The following items are conditions for permit issuance and strict compliance is mandatory.

Figure 1. Recommended construction details for APA portal frame bracing without hold-downs

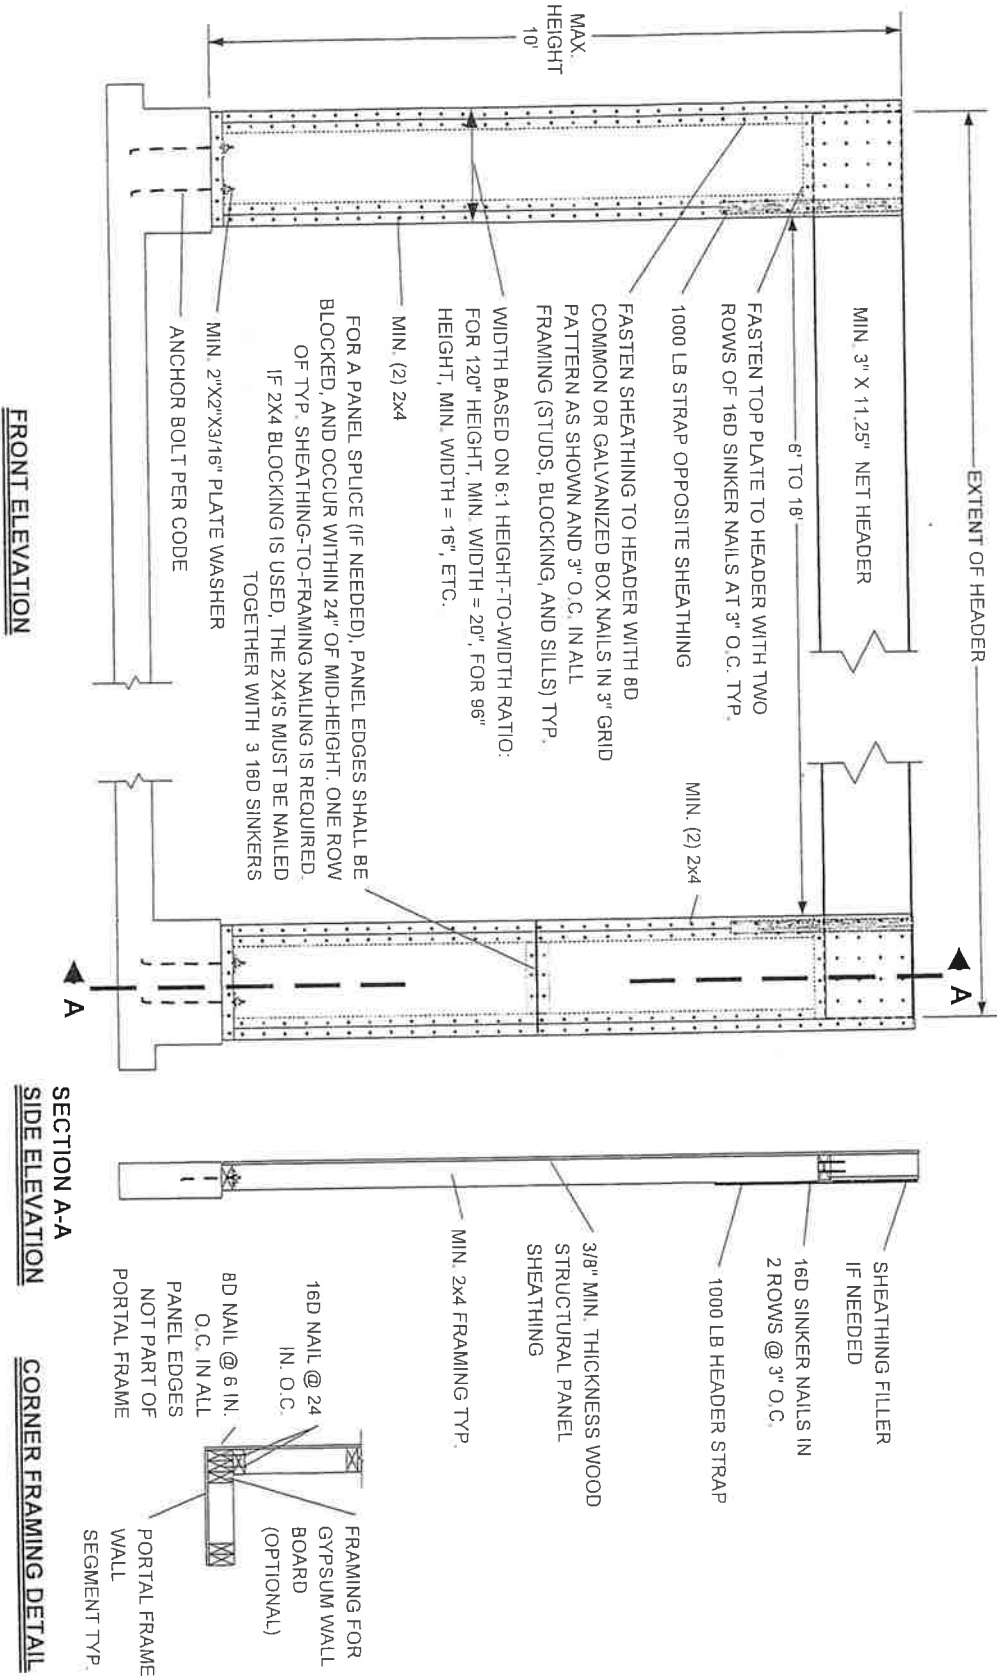
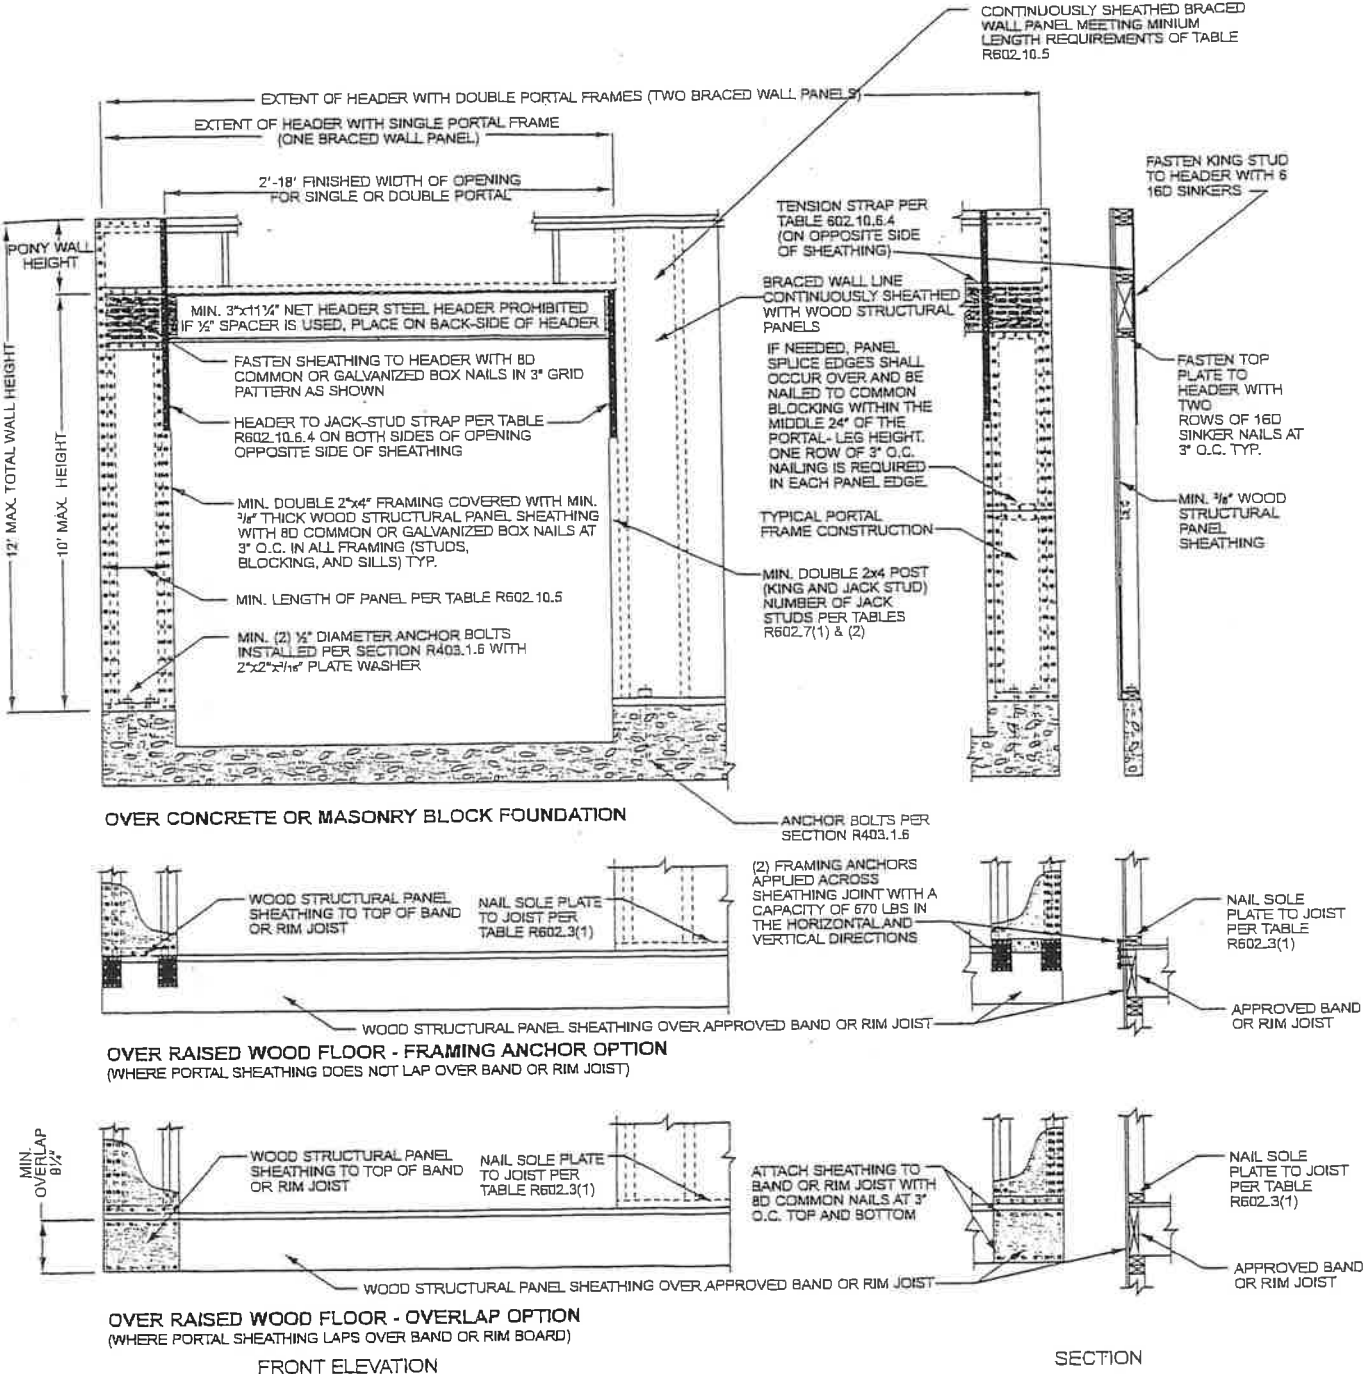
BRACED WALL PANEL
